ND-2011-0066
December 9, 2011

Subject: PSEG Early Site Permit Application
Docket No. 52-043
**Supplemental Response to Request for Additional Information, RAI
No. 39, Probable Maximum Surge and Seiche Flooding**

RESPONSE to RAI No. 39

PSEG Power, LLC
 PSEG Site ESPA
 Part 2, RAI No. 39
 Fetch Lengths between East
 Northeast and Southwest Direction
 Figure RAI 39-10-1
 Rev. 0

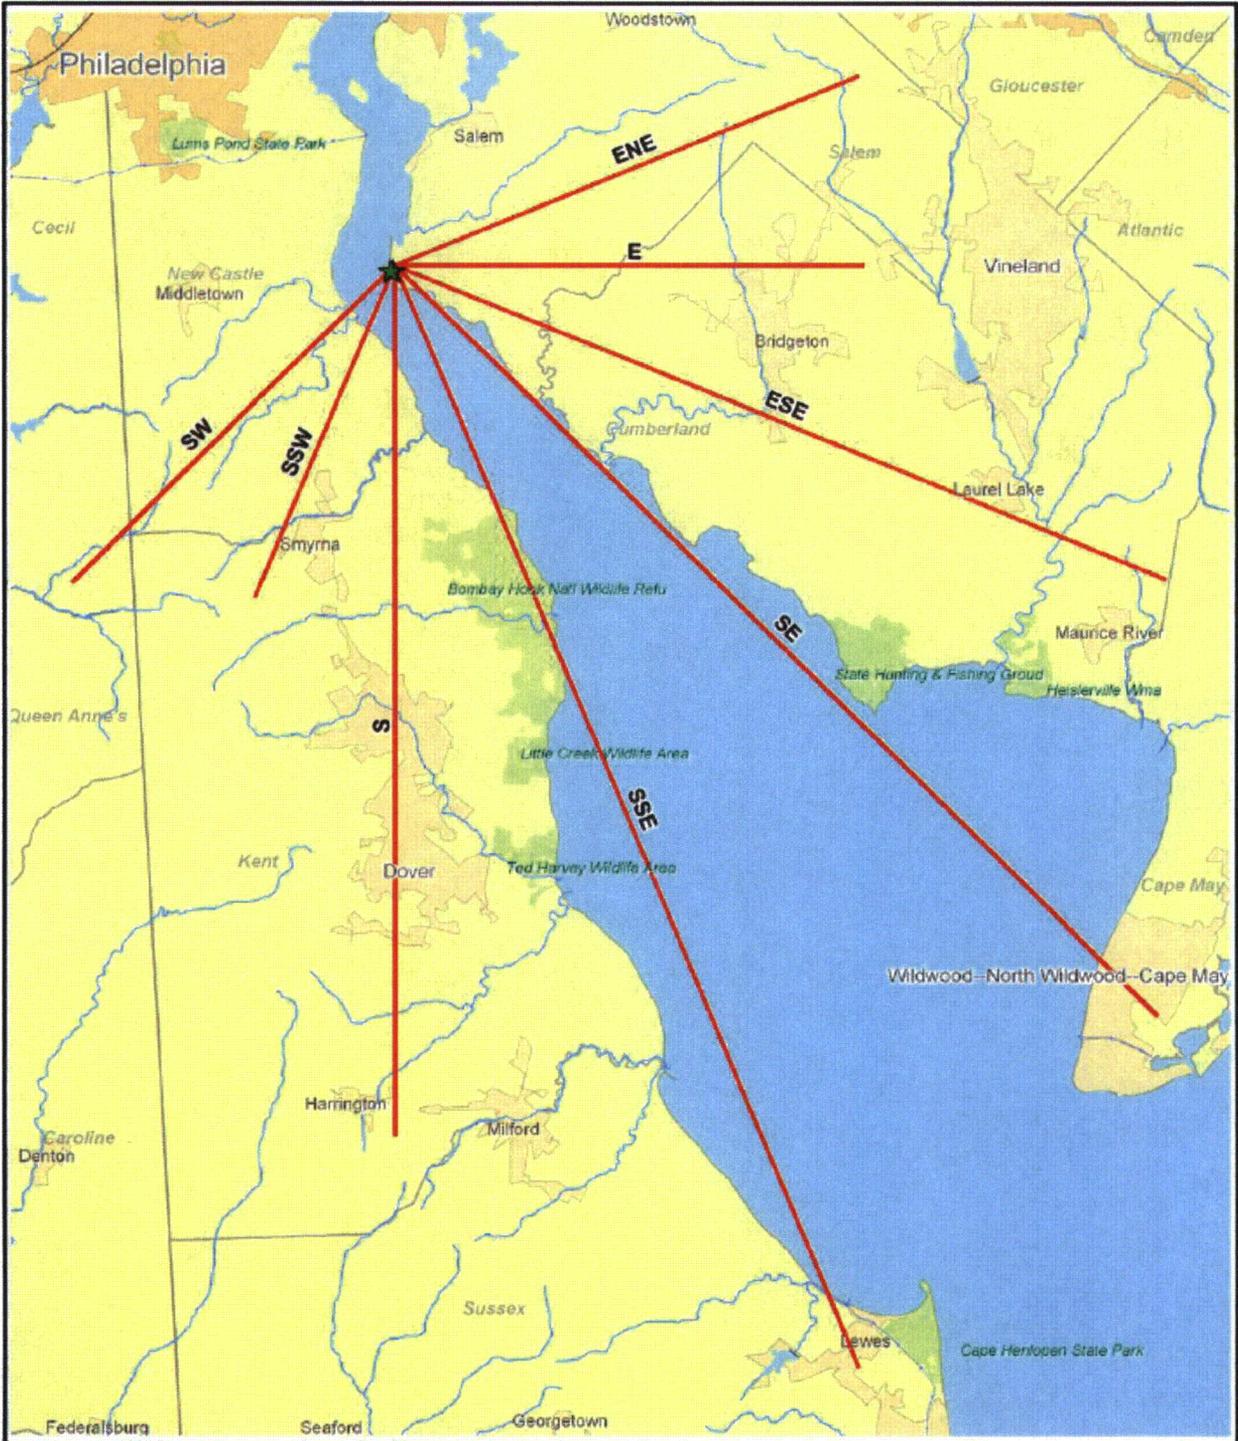
To meet the requirements of GDC 2, 10 CFR 52.17, and 10 CFR Part 100, estimates of the probable maximum hurricane (PMH) and the probable maximum storm surge are needed. The storm surge induced by the PMH can be estimated as recommended by Regulatory Guide 1.59, supplemented by current best practices. SSAR Section 2.4.5.3.2 discusses the development of the wave runoff estimate for the project site. The NRC staff requests that PSEG provide details of the equations and parameters applied to estimate the wind-induced wave runoff at the project site. Specifically, the NRC staff requests that PSEG provide information on the equations applied, the wind speed averaging calculations, and the breaking ratio applied. In addition, the NRC staff requests that PSEG clearly define the wave heights (maximum versus significant) applied in the equations.

Significant wave height is estimated along eight different fetch lines radiating out at selected compass directions from the new plant. Several fetches were chosen to ensure that the calculated wave height represents an accurate estimate of the highest possible level occurring during the PMH, due to the dramatic shift in wind direction as the storm center passes by the new plant. During the time of highest surge the winds are primarily originating out of the southeastern quadrant. Therefore, the eight fetches are between the East, Northeast and Southwest directions at common 22.5 degree differences. Fetches are generated in GIS to determine distance and depth/elevation profiles along the fetch using NOAA Bathymetry of Delaware Bay (SSAR Reference 2.4.5-19) and elevation data of the land surrounding Delaware Bay from USGS topography data (SSAR Reference 2.4.5-30). Each fetch is identified in Figure RAI 39-10-1.
